TfNSW Reference: SYD10/00774/40

Client Reference: MP10\_0118 MOD 12

## **RESPONSE TO SUBMISSIONS FOR EDMONDSON PARK CONCEPT PLAN - EDMONDSON PARK TOWN CENTRE**

# TfNSW Operational Traffic Modelling Team Review and Comments

Figure 1: 2026 PM signals at Campbelltown Rd / Soldier Pde

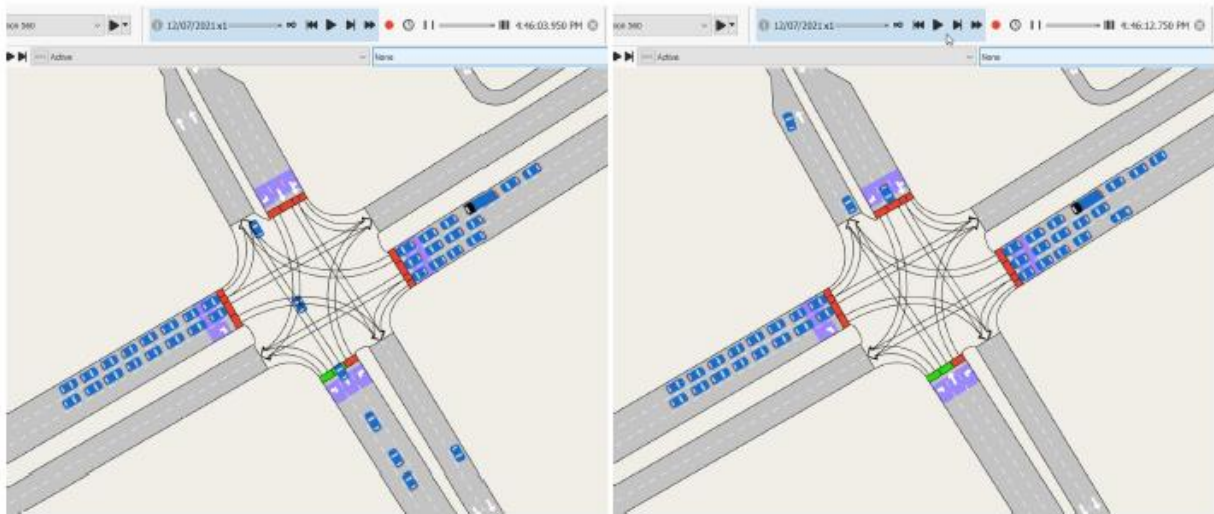
3	School zone	Only one section in the southbound direction along MacDonald Rd south of Campbelltown Rd has a school zone speed change applied (via traffic management). However, the section running immediately downstream does not and neither do the northbound sections running opposite	Minor
4	Signals	The Campbelltown Rd / Soldiers Pde intersection has been coded with intergreens of 6s whereas SCATS shows intergreen times of 8s for each phase	Minor
5	Signals	A few intersections do not seem to have signal actuation set up optimally. One example is the Campbelltown Rd / Soldier Pde intersection in the 2026 PM scenario. As shown in Figure 1, the southbound movement on the north approach first turns red. However, the corresponding northbound movement continues to remain green for several seconds afterwards. Over this time, another vehicle has already arrived at the north approach but is unable to pass the intersection as that movement had prematurely turned red	Minor

Figure 2: PM sqlite files not provided

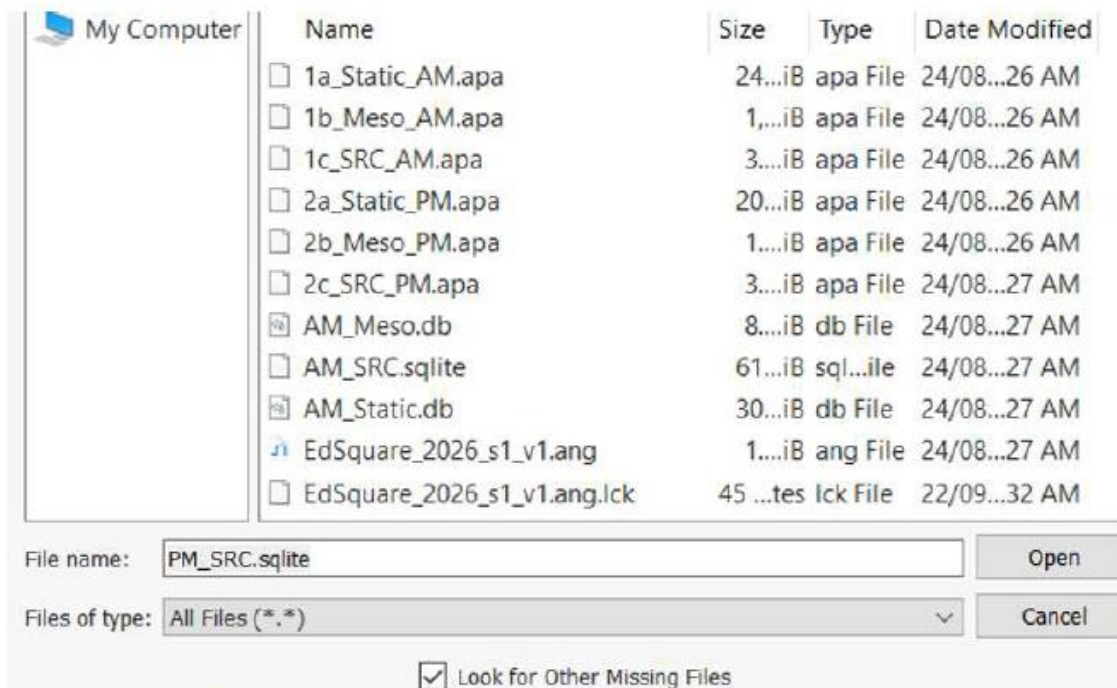
6	Demands	The demands have been input into the model as one hour blocks. It is recommended to use 15 minutely profiles based off survey data as using just a one hour block may underestimate the traffic impact during the peak	Major
7	Vehicle parameters	Certain vehicle parameters appear to have been changed from the default (e.g. car widths, lateral clearances of all vehicles, imprudent lane changing, etc.). Justification for making these changes should be provided in the documentation	Minor
8	Experiment parameters	The relative gap parameter in the mesoscopic DUE scenarios appear to have been increased from the default of 0.5% to 1.5%. Justification for changing this should be provided in the documentation	Medium
9	Results	The PM results could not be retrieved as the PM sqlite files were not provided as seen in Figure 2	Minor
10	Results	A number of high volume OD pairs appear to have a variety of routes, each with a similar number of vehicles as shown in Figure 3 and Figure 4. This seems quite unusual given the intersection performance presented in the documentation	Minor
